CITY OF RAYMORE

ADDENDUM NO. 1

West Hawk Ridge Improvements
Project #22-386-201

Addendum No. 1 - BID DATE REVISED - Question and clarification.

ASPHALT PAVEMENT SECTION
 ACCESS ROAD AND PARKING LOT
 NOT TO SCALE

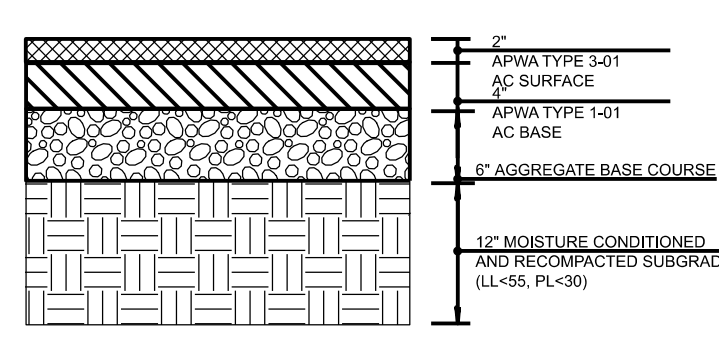
14. Question: Is the thickness of the parking lot asphalt pavement also to be 8" total?

Answer: Yes per the typical section sheet pavement detail in the lower left hand corner.

**SITE LAYOUT
BASE BID**

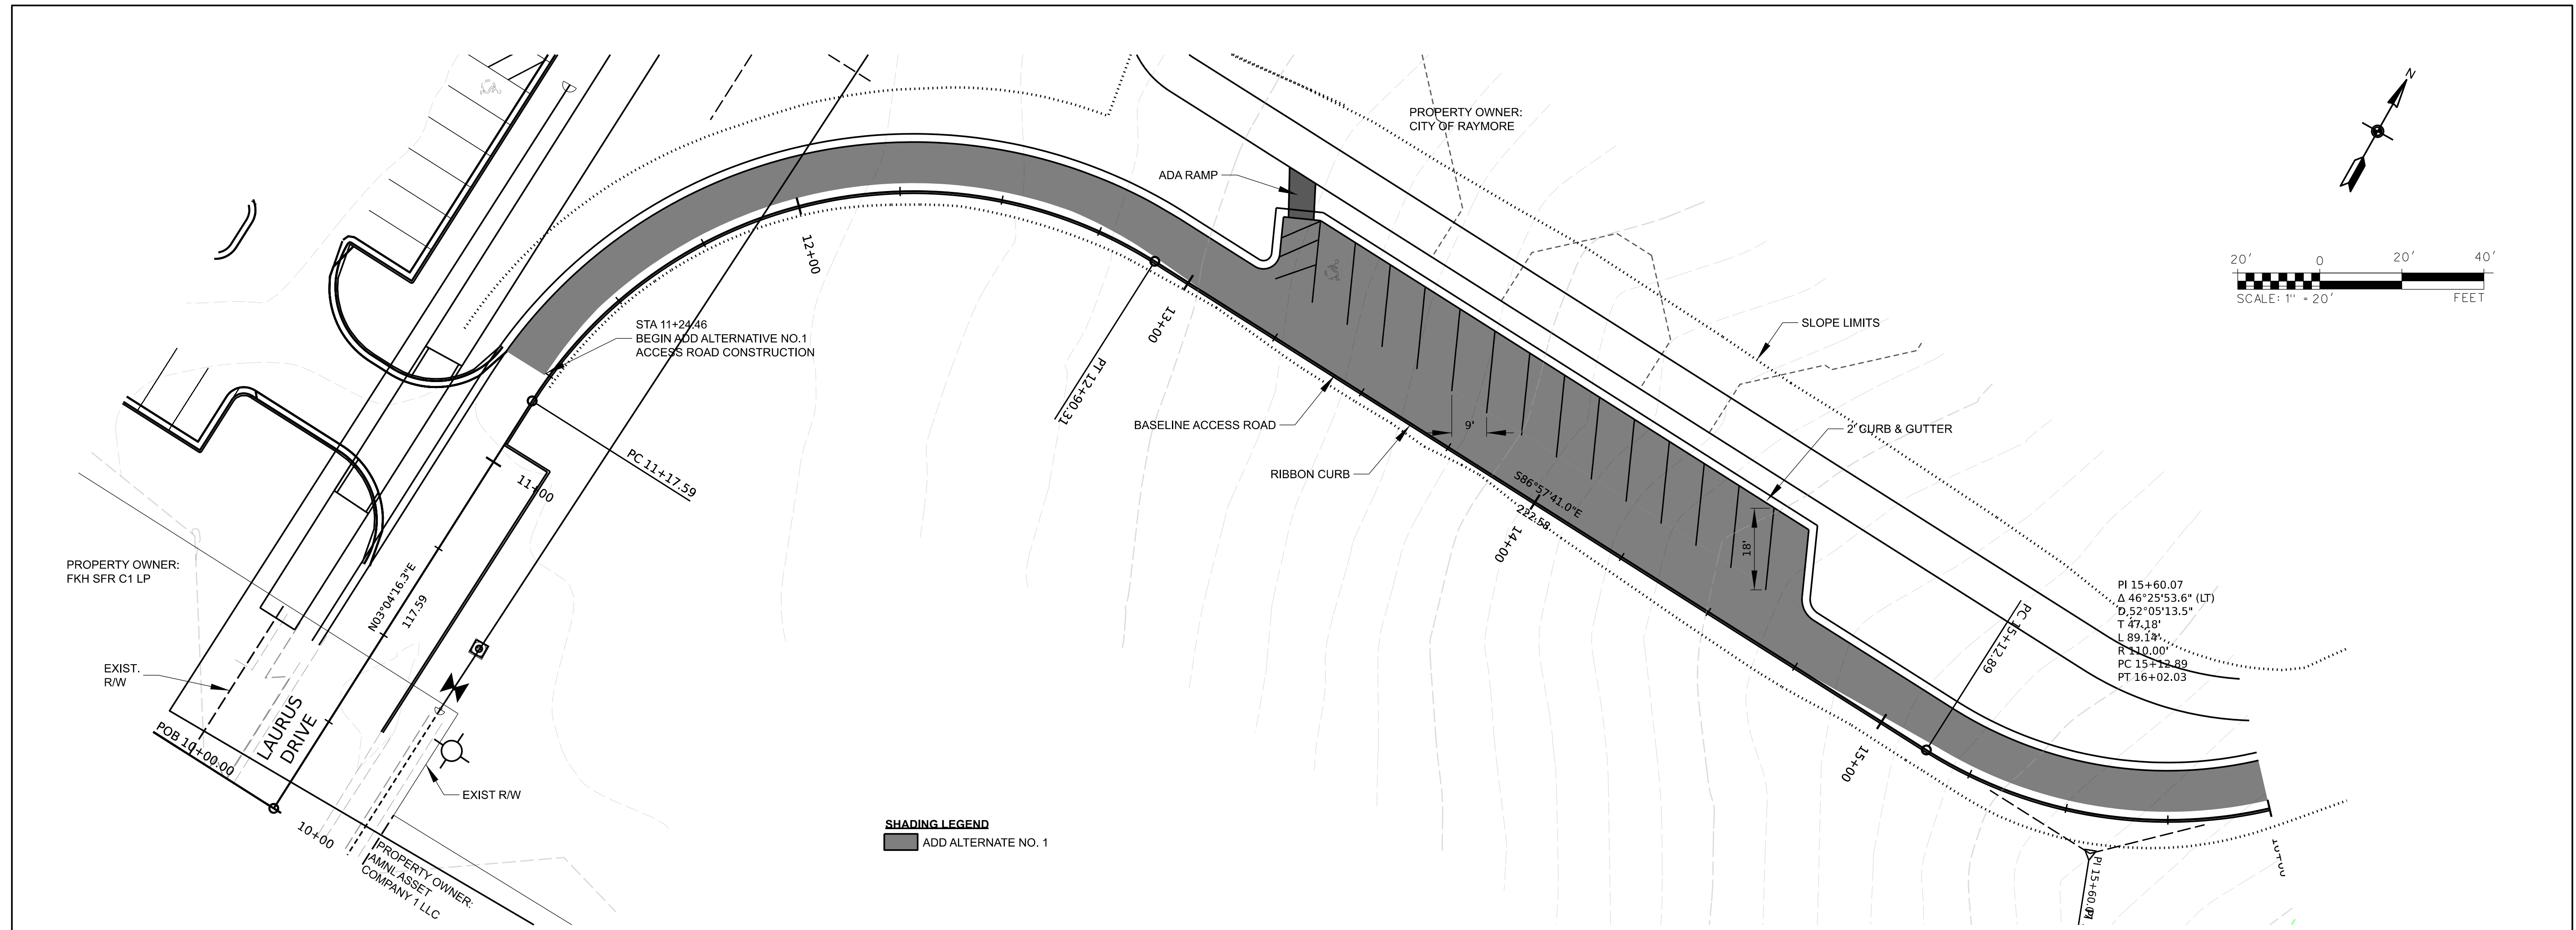
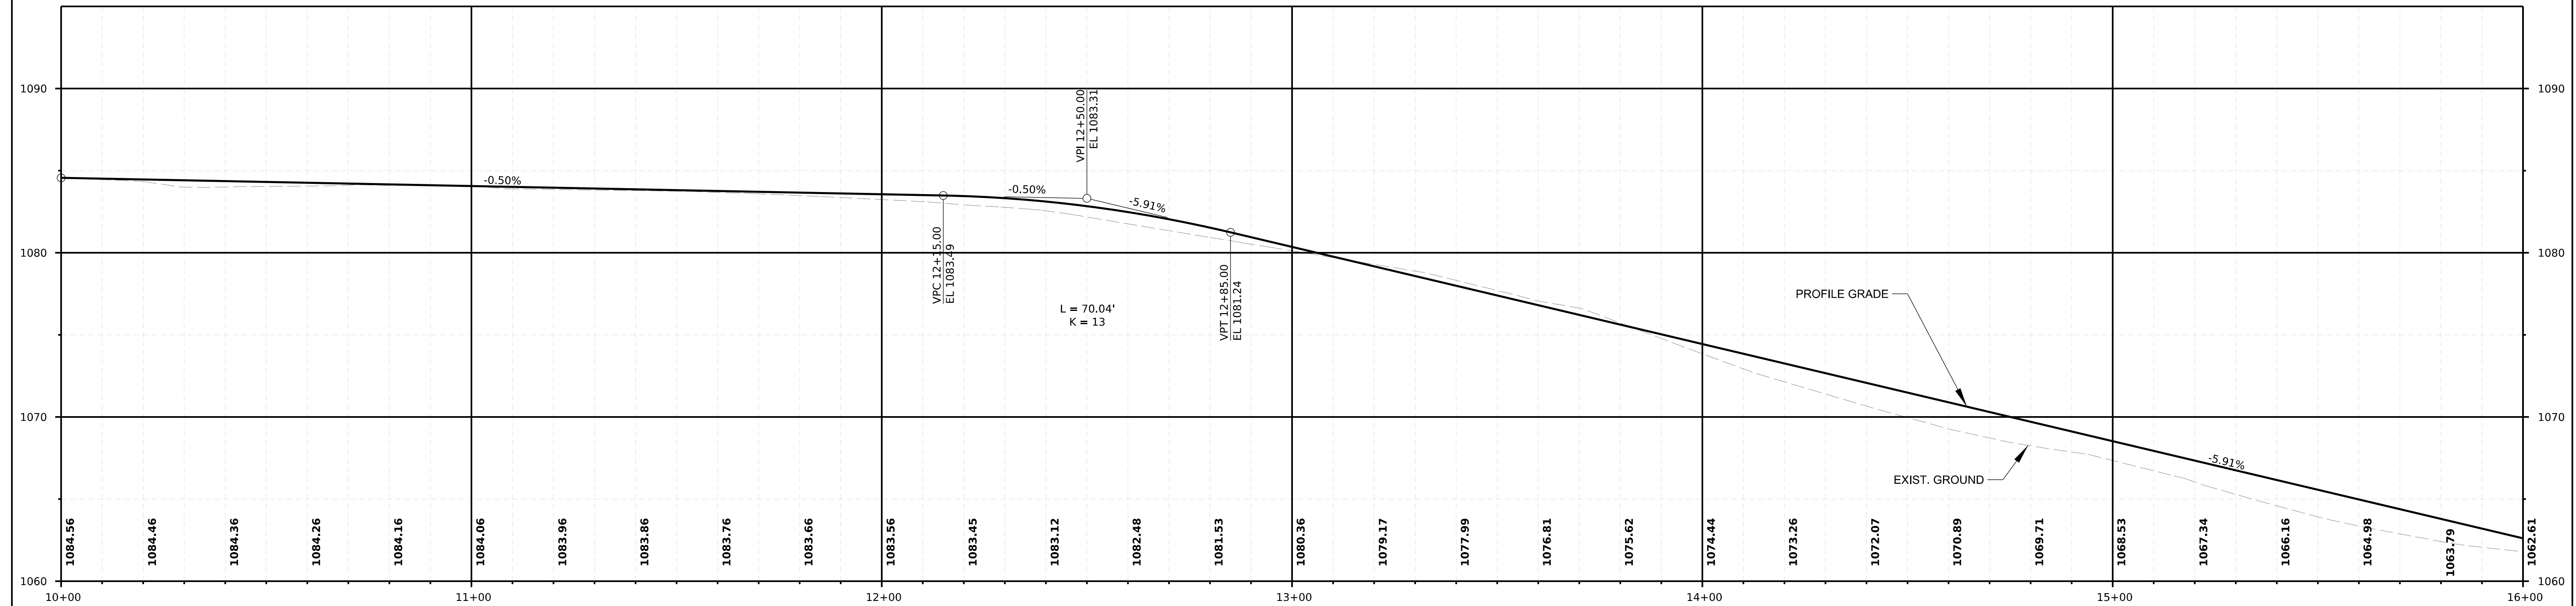
17. Question: There does not appear to be a pay item for the two "10' concrete grass parking access" pads shown on sheet 5 of the plans.

Answer: A pay item has been added to the bid tab.
